AIA
Austin

CodeNEXT Charrette 2 Report

Published by the Austin Chapter of the American Institute of Architects
January 2, 2018

LANDSCAPE PLAN

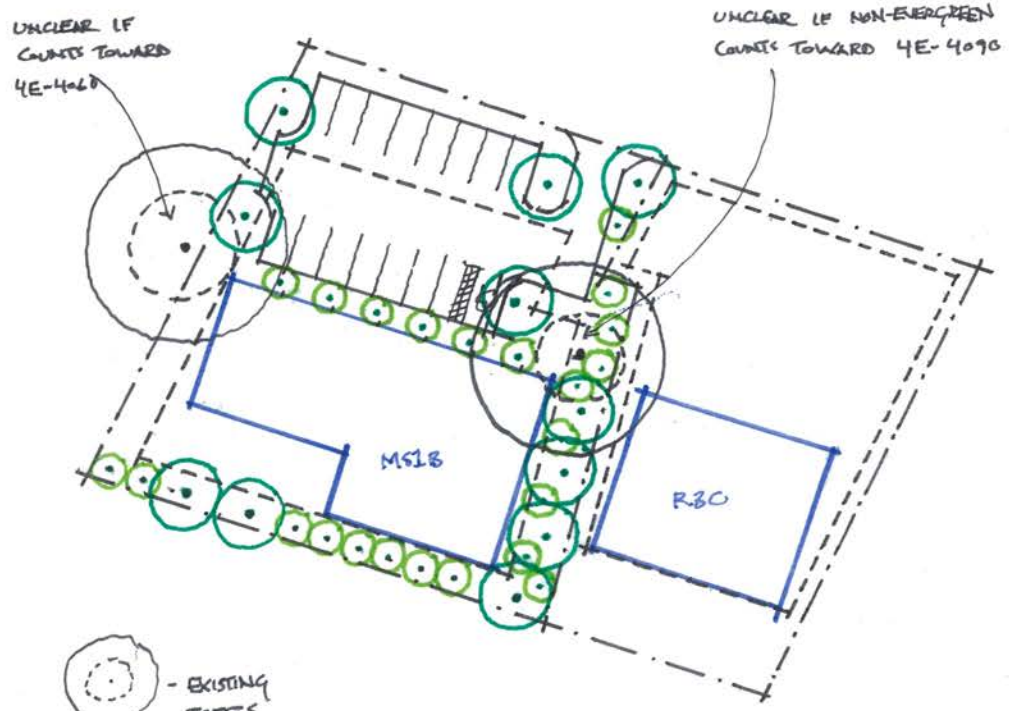
- MS1B - (3) SHADE TREES, (8) ORNAMENTAL TREES
- R30 - NONE

- MS1B - (6) ORNAMENTAL ~~SHADE~~ TREES (SIDEWALK DOESN'T FIT)
- R30 - NONE

- MS1B - (4) SHADE TREES (2 PARKING SPACES REMOVED)
 - R30 - NONE
- ↑ PARKING BAY REQS, NOT LANDSCAPE

- MS1B - (4) SHADE TREES, (9) ORNAMENTAL TREES
- R30 - NONE

Figure 3.2: Webberville Rowhouse Study

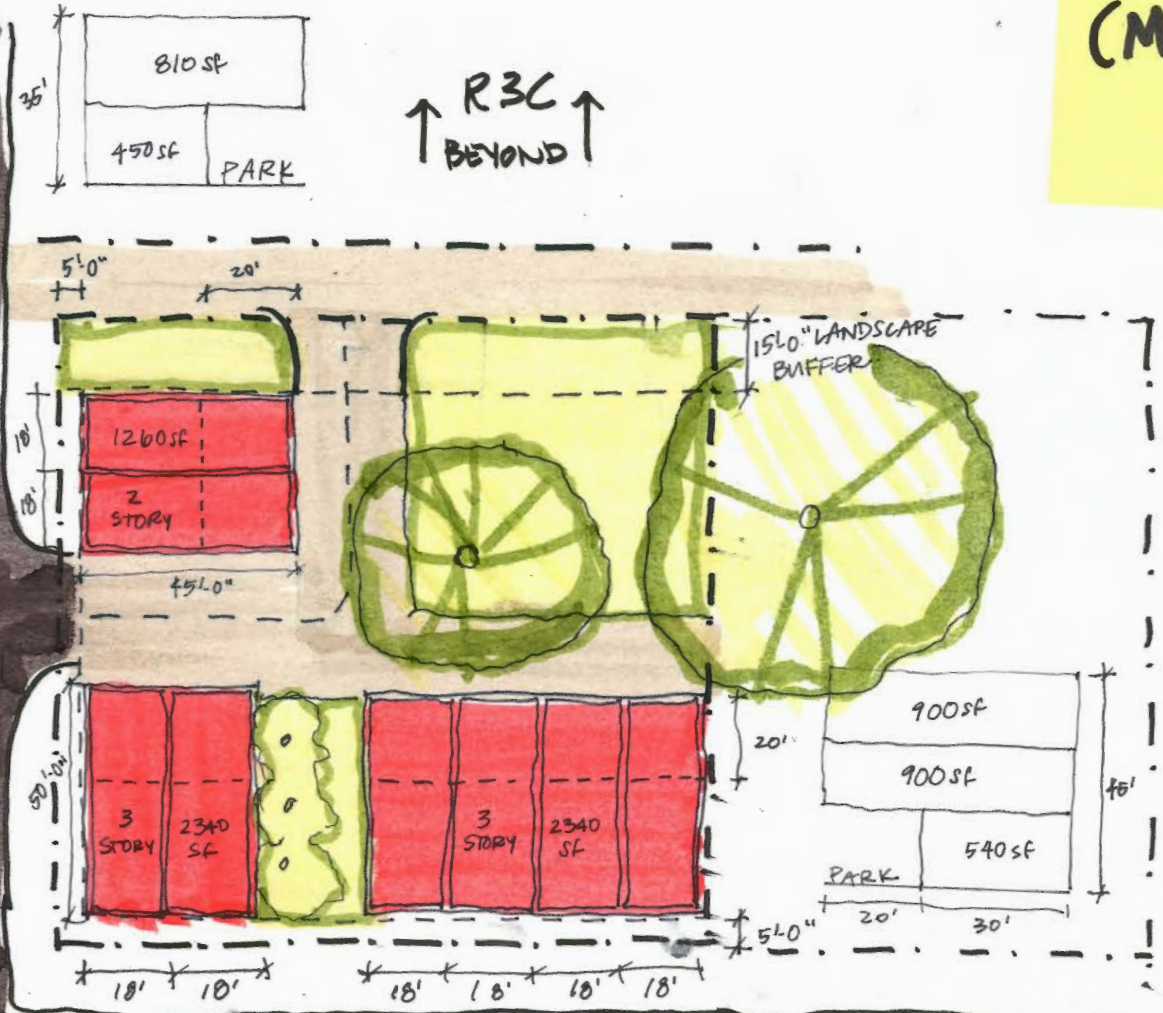
★ PARKING ASSUMES
 1 ROWHOUSE = 1 UNIT -
 NOT GROUP HOUSING ★
 (unclear in code how
 to count, what qualifies
 as group housing)

Figure 7.1: 5th and Colorado test site developed as office under the current LDC vs. CodeNEXT 2.0

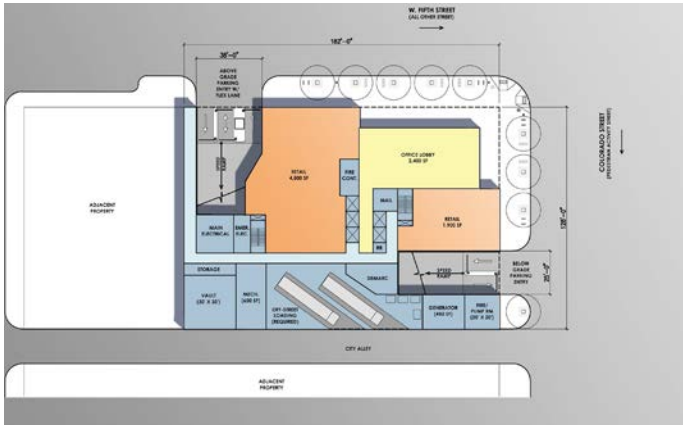
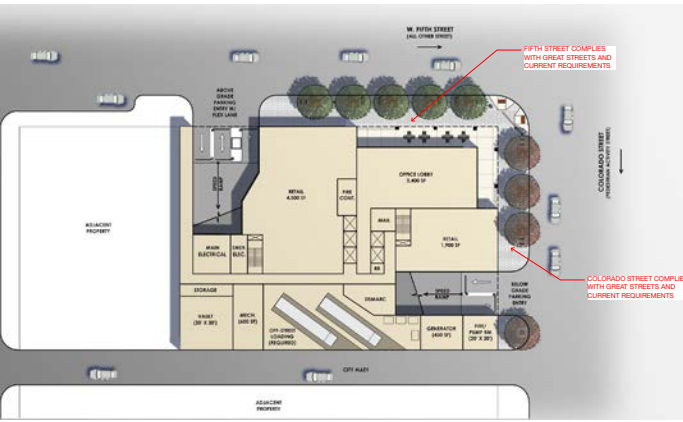
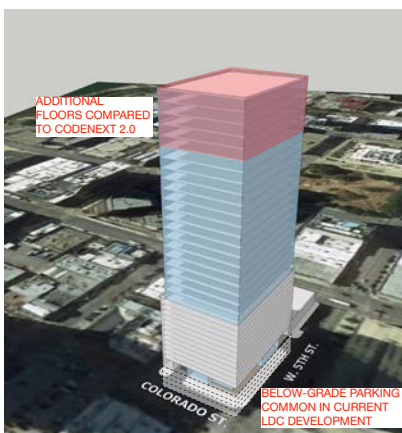
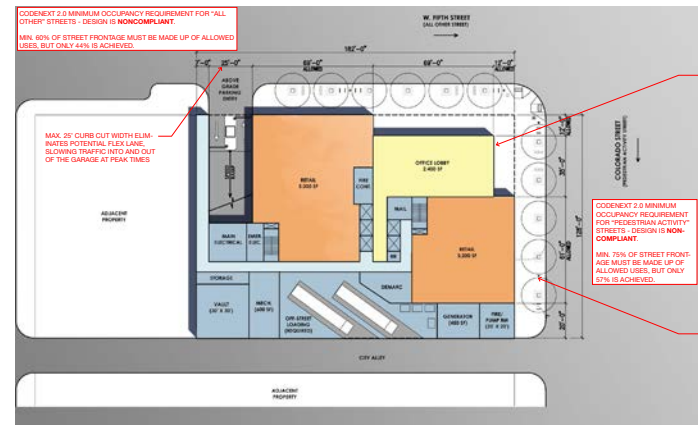
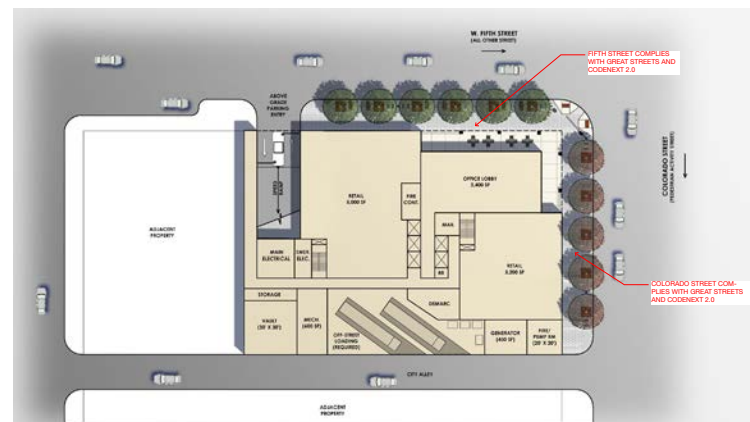
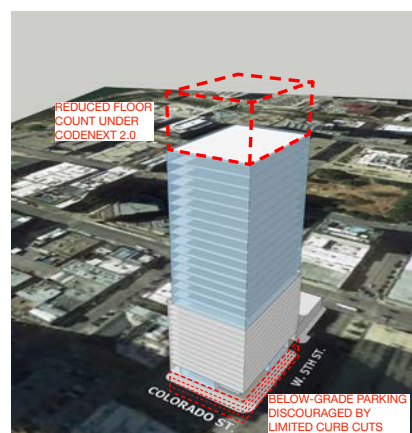
OFFICE UNDER LDC:
 34 Stories - 402' Tall
 445,250 GSF
 870 Parking Stalls
 18.9:1 FAR Achieved

OFFICE UNDER CODENEXT 2.0:
 30% Yield Reduction from LDC Massing
 29 Stories - 332' Tall
 342,750 GSF
 663 Parking Stalls
 14.6:1 FAR Achieved
